# Access Compliance Report

## Public Rights-of-Way

### (Curb Ramps)

Intersection ID: 27333	Main Street: BALLANTYNE_MEDICAL_PL	Cross Street: BRIXHAM_HILL_AV	Location: W
ADA ID: 0D0CAB74DCD0	Ramp Type: Perp	Initial Pass/Fail: Fail	Overall Compliance: No
Severity Score: 12.5			
Codes/Mitigation Info/Possible Solution		Field Measurements/Component Compliance

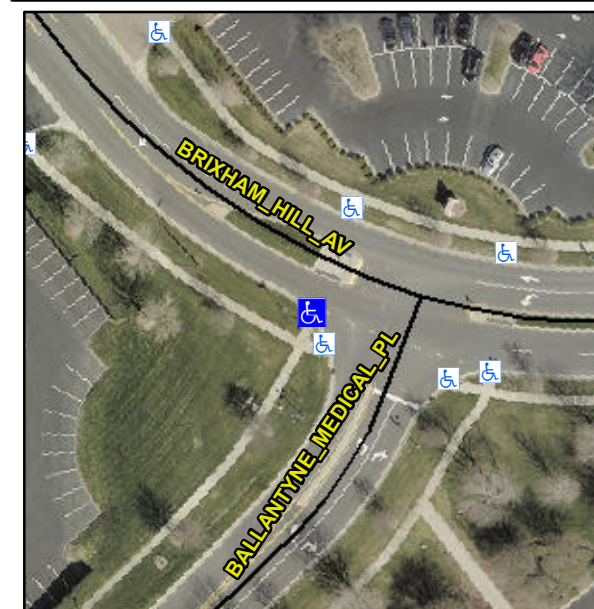
**Remove & Replace Entire Ramp.**

**R304.5.3**

Compliance	Description	Data	Compliance	Description	Data
N/A	Ramp Length (in)	114.0	Yes	Ramp Slope (%)	6.6
Yes	Ramp Width (in)	55.0	No	Ramp XSlope (%)	5.3
N/A	Flare Type LT	N/A	N/A	Flare Type RT	N/A
N/A	Flare Slope LT (%)	N/A	N/A	Flare Slope RT (%)	N/A
N/A	Flare Traversable LT?	N/A	N/A	Flare Traversable RT?	N/A
N/A	Landing Length (in)	N/A	N/A	DWS Provided?	N/A
N/A	Landing Width (in)	N/A	N/A	DWS Contrast?	N/A
N/A	Landing Slope (%)	N/A	N/A	DWS Length (in)	N/A
N/A	Landing X Slope (%)	N/A	N/A	DWS Full Width?	N/A
N/A	Landing Curb? (Y/N)	N/A	N/A	DWS Offset (in)	N/A
N/A	Shared Landing?	N/A			
N/A	Gutter Ponding?	N/A	N/A	Gutter Slope (%)	N/A
N/A	Gutter Lip Ht (in)	N/A	N/A	Gutter X Slope (%)	N/A
N/A	Painted X Walk1?	No	N/A	Painted X Walk2?	N/A
	X Walk 1 Direction	To NE		X Walk 2 Direction	N/A
N/A	X Walk 1 Width (in)	N/A	N/A	X Walk 2 Width (in)	N/A
	X Walk 1 Slope (%)	4.5		X Walk 2 Slope (%)	N/A
	X Walk 1 X Slope (%)	0.3		X Walk 2 X Slope (%)	N/A
